**WNI RESPONSE TO NRC REQUEST OF 9/6/01  
FOR ADDITIONAL INFORMATION ON  
SITE CLOSURE PLAN FOR THE  
SPLIT ROCK, WYOMING SITE**

**May 2002**

**FIGURE 1-7**  
SOLID PHASE Ra226, Th230, URANIUM FROM SELECT LOCATIONS,  
WESTERN NUCLEAR SPLIT ROCK SITE, JEFFREY CITY, WYOMING

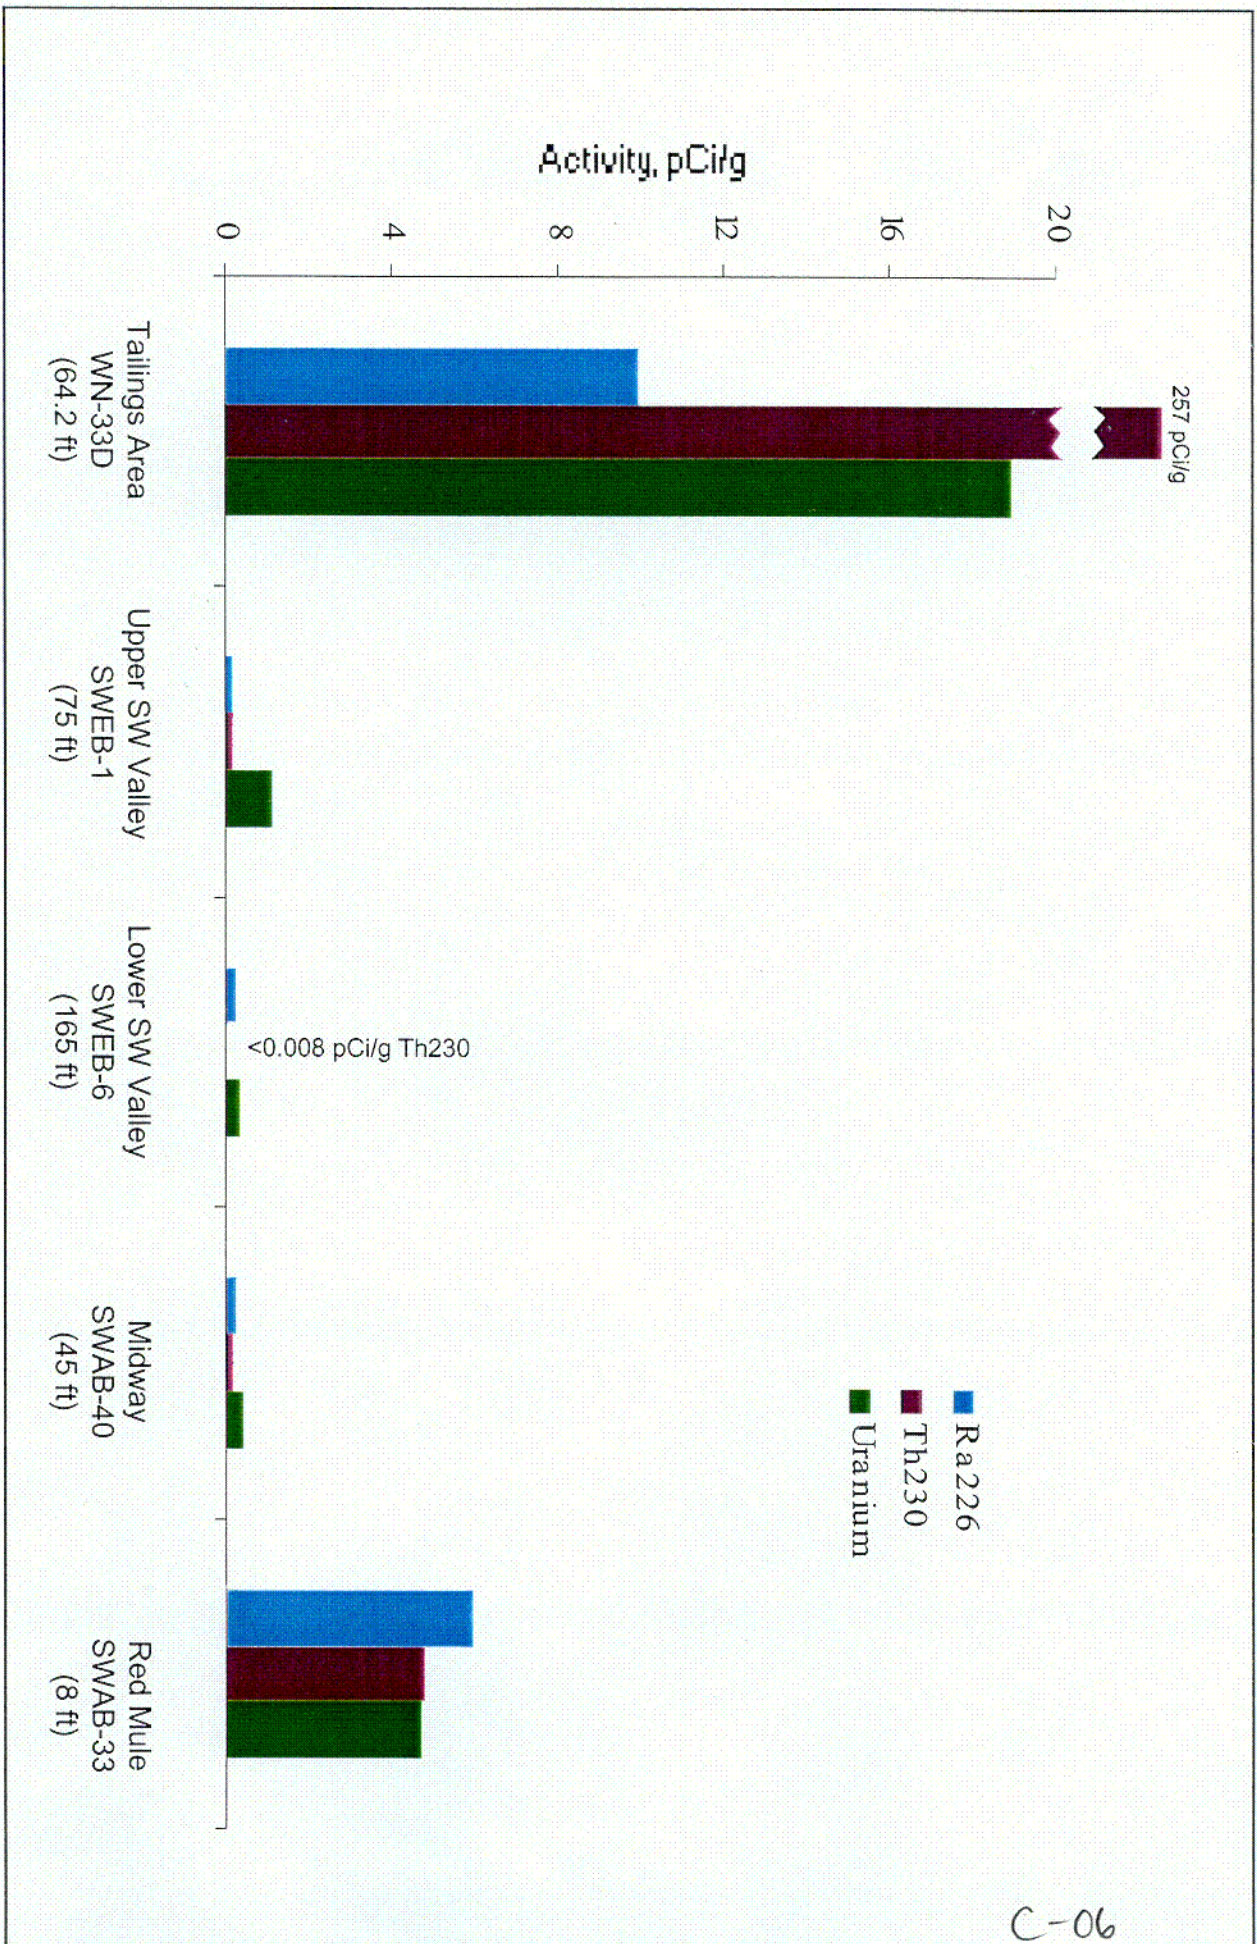
The RAI points out that the Site Closure Plan (SMI 1999) states that, *"a groundwater plume bearing uranium from the Split Rock site that enters a non-mineralized area might have high uranium concentrations in water and low Th-230 and Ra-226 ratios"*. The NRC also points out that examination of Table F-n-1 indicates that wells RM-1 and WM-1 in the Red Mule area fits this description. It should be emphasized that the above statement regarding the concentration of uranium compared to levels of thorium and radium is specific for groundwater entering a "non-mineralized" area. This is a result of the rapid removal of thorium and radium from the contaminant plume via precipitation and/or adsorption reactions within the soil matrix. In contrast, uranium, especially when complexed with carbonate, tends to be considerably more mobile in groundwater than the other two constituents (Landa, 1995). However, the same statement could be made in an area in which uranium-bearing minerals are present, particularly if groundwater in the area is near neutral and carbonate rich. As the minerals weather, uranium is complexed with bicarbonate and mobilized yielding groundwater uranium concentrations that are elevated with respect to radium and thorium which are rapidly sorbed or precipitate in near neutral environments. However, the same reasoning is applicable in the statement that the very low values of Th-230 observed at the Johnson well would suggest the presence of naturally occurring uranium deposits. All current literature indicated that thorium associated with uranium mill tailings rapidly precipitates as tailings solution is leached into the surrounding soils. This has been discussed above in Geochemistry

Question No. 6 and aptly illustrated in Figure 1-7. Thus, the transport of thorium more than a few hundred feet from a tailings impoundment has not been demonstrated and therefore transport of thorium from the millsite to the Red Mule area (a distance of approximately 2 miles) is not supported by current knowledge of thorium geochemistry. In contrast, data collected during the 2002 SDCP supports the presence of natural uranium bearing minerals in the Red Mule area along with the concomitant elevation in solid phase radium and thorium (Figures 1-9, 1-10, and 4-1). Again, as discussed in Geochemistry Question No. 6 above, these radionuclides in soils found at the Red Mule subdivision are also approximately in secular equilibrium, indicating that they are naturally occurring and not transported from the Split Rock facility.

FIGURE 2-2  
PROPOSED SURFACE WATER AND GROUND WATER SAMPLING  
LOCATIONS FOR LONG TERM MONITORING

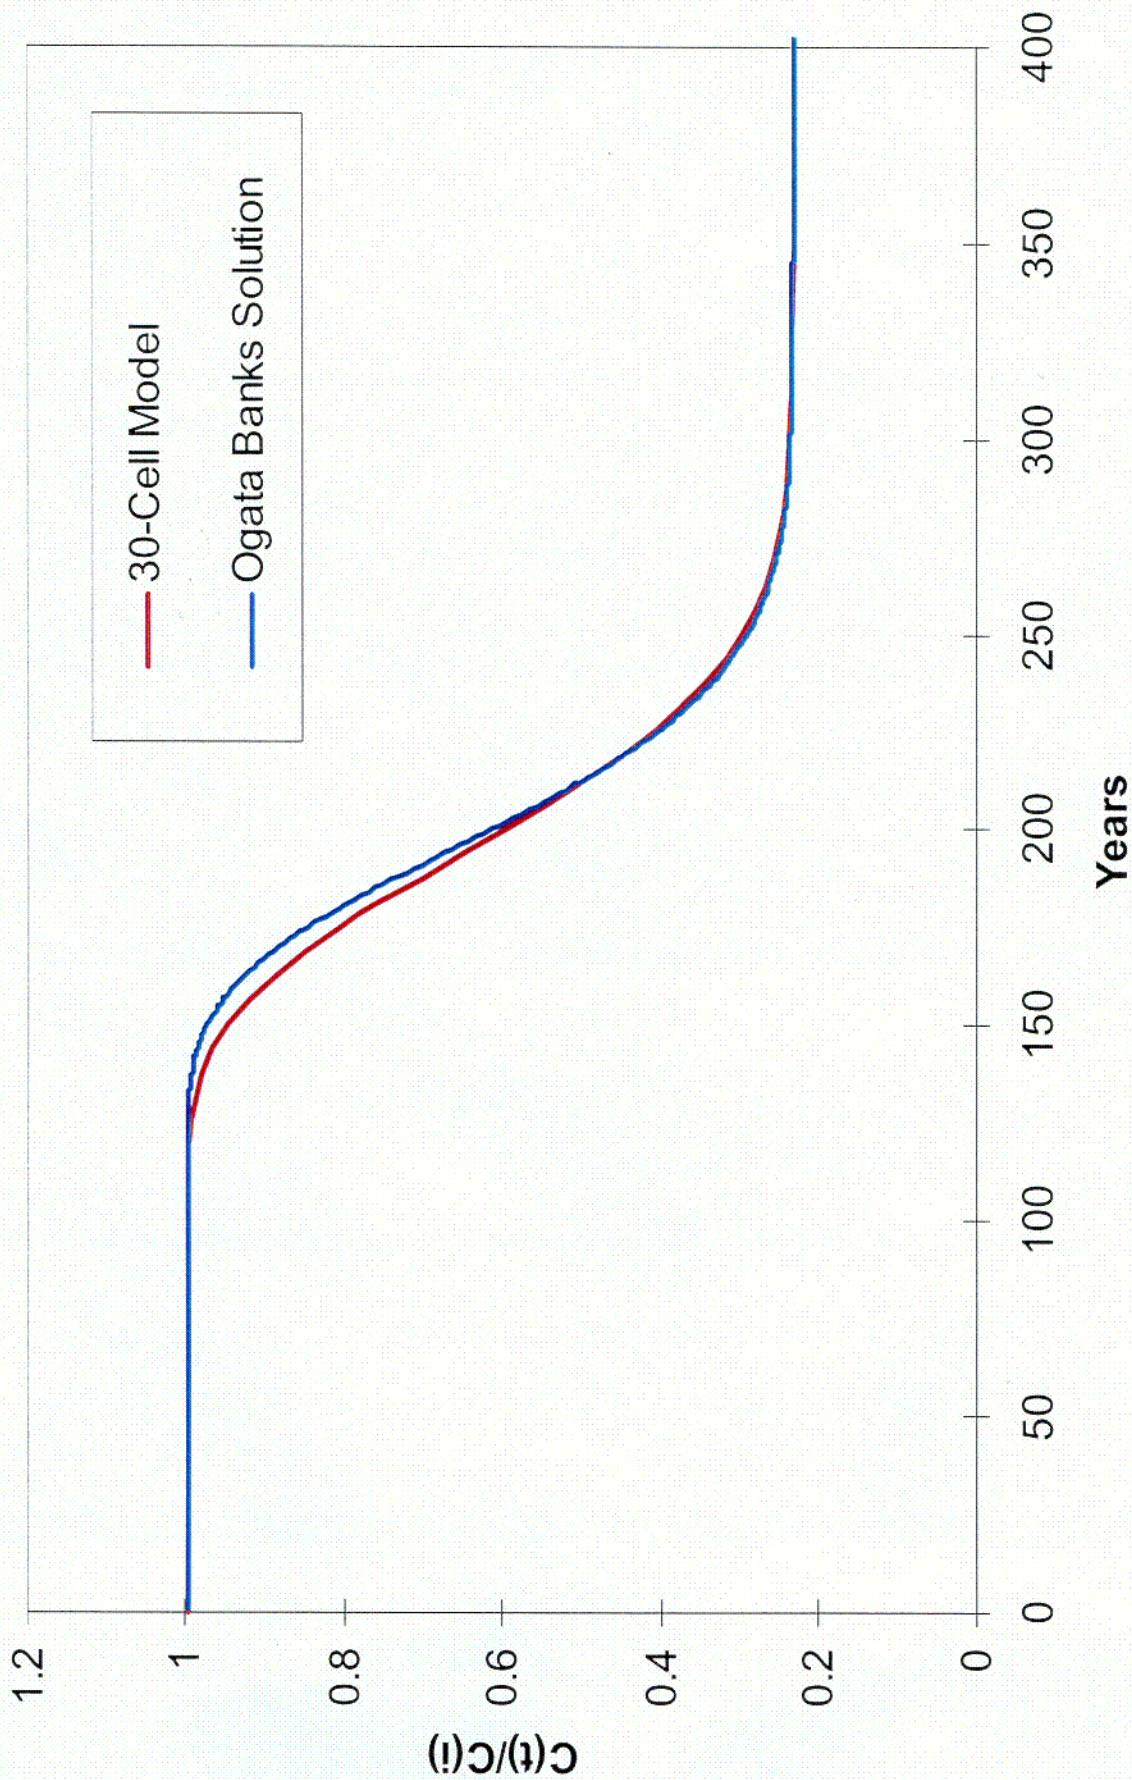
**Item No. 2:** *Propose a long-term groundwater and surface water monitoring program. The program should start off with a higher frequency immediately after*

*groundwater pumping ceases with decreased frequency over time. Uranium, sulfate, and chloride should be analyzed in groundwater and surface water, and ammonia should also be analyzed in surface water. Adequate coverage is needed to monitor water quality between the plume and the Jeffrey City water supply wells, near Claytor Ranch wells, Red Mule, and in the Sweetwater River (locations where seepage is highest, downstream, and up-stream background). Adequate long-term surety must be set aside to fund this groundwater monitoring program.*

Annual surface water monitoring is proposed for the three locations illustrated in the attached Figure 2-2 for the first five years of monitoring. These sampling points represent locations upgradient of any potential site loading, adjacent to the site where maximum site loading is anticipated and downgradient of site loading. After five years, a sampling frequency of once every five years will be sufficient to demonstrate protective conditions are being maintained and model predictions are not exceeded.

Annual groundwater monitoring is proposed for the locations illustrated in the attached Figure 2-2.

The sampling locations represent monitoring points between the site and Jeffrey City water supply wells (SWAB-30 and SWEB-13), between the site and the Red Mule Area (SWAB-31 and SWEB-16), and the Northwest Valley and the Sweetwater River Floodplain (Well-4R).

FIGURE 3-1  
COMPARISON OF 30-CELL MODEL AND OGATA-BANKS SOLUTION

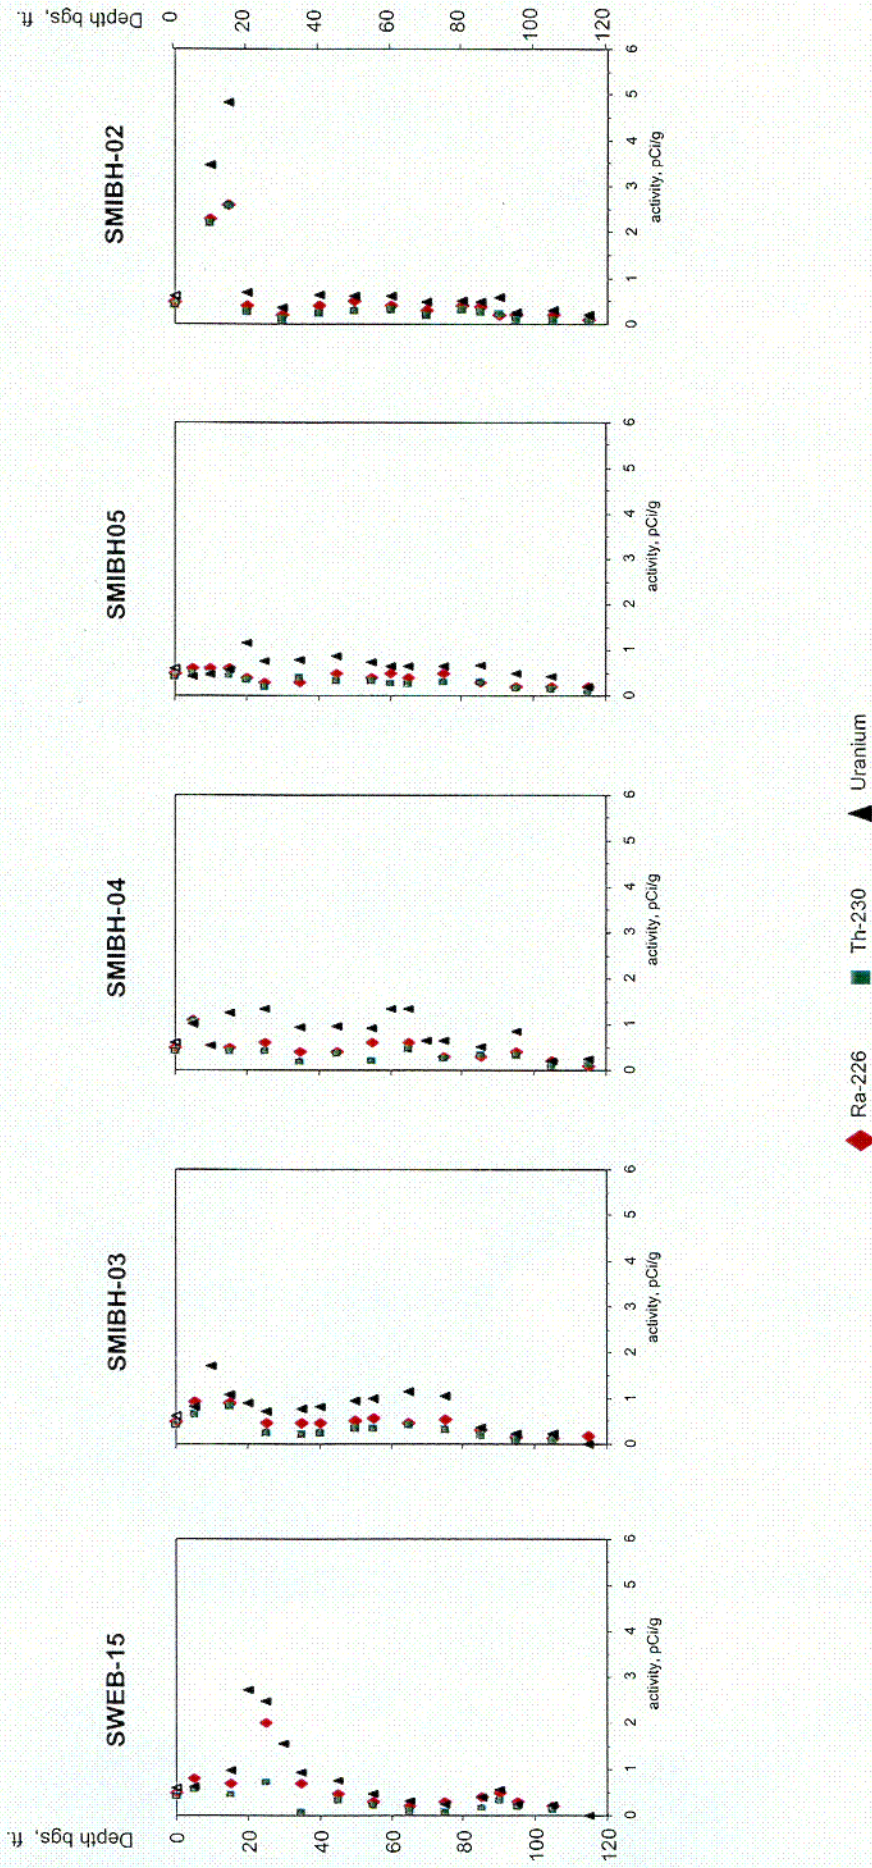
**Question 27:** *The representation of the mass balance model used as part of the one-dimensional spreadsheet model may be in error. As presented in the report (i.e., on page H-c-14), the mass balance model has incompatible units. To have consistent units, it would appear that source and sink terms would need to be multiplied by the time over which flow occurs. Please verify that the correct equation was used in the analysis. In addition, to allow a check of WNI's verification of the model, please include input and results from the verification analysis.*

The 30-cell model results have been compared against the Ogata Banks solution to the one-dimensional advection-dispersion equation. The formulation and input parameters for the Ogata Banks solution are presented in the response to Question 26. The comparison is presented in Table 3-2 and Figure 3-1. The dissolved concentrations

FIGURE 4-3  
AQUEOUS VERSUS SOLID PHASE URANIUM CONCENTRATIONS IN THE  
RED MULE AREA

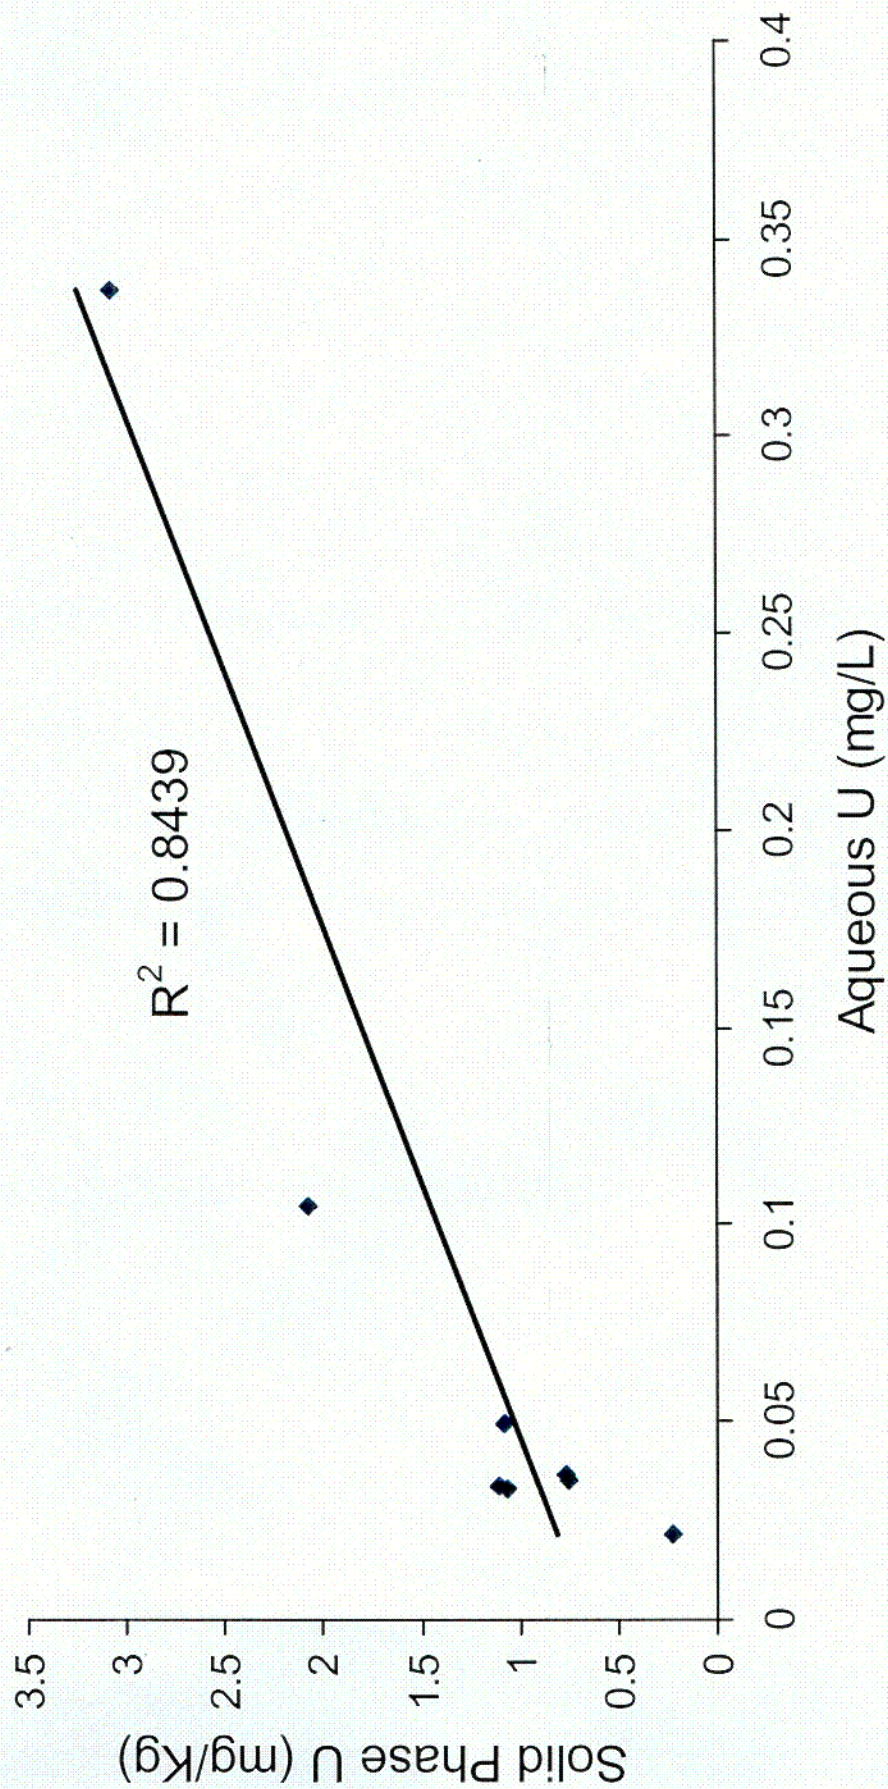
**Question 9:**      *Geochemical evidence must be provided to demonstrate that the low uranium mineral contents found in sediments above the water table correlate to the concentrations of dissolved uranium found in (shallow and deep) groundwater at Red Mule. Additional information is needed to explain the potential influence of K-40 on the KUT borehole log results and the comparison of the log data to the sediment data should result in similar values for uranium.*

Mule area. This figure illustrates two important points. First, there is a considerable gap, approximately one mile, from well SWAB-17 to well SWEB-15 in which the levels of uranium in groundwater (shallow and deep) is well below background levels. Secondly, a comparison of levels of dissolved uranium measured at wells and the solid phase concentration of uranium in the overlying solid phase suggests a strong link between the presence of high-uranium solids with elevated aqueous concentrations. Plotting the dissolved uranium concentration measured at SWAB-40, SWAB-31, SWAB-39, and SWAB-33 against the concentration of uranium measured in the adjacent overlying solid phase (Figure 4-3) demonstrates a significant correlation ( $R^2 = 0.84$ ) between aqueous and solid phase uranium levels.
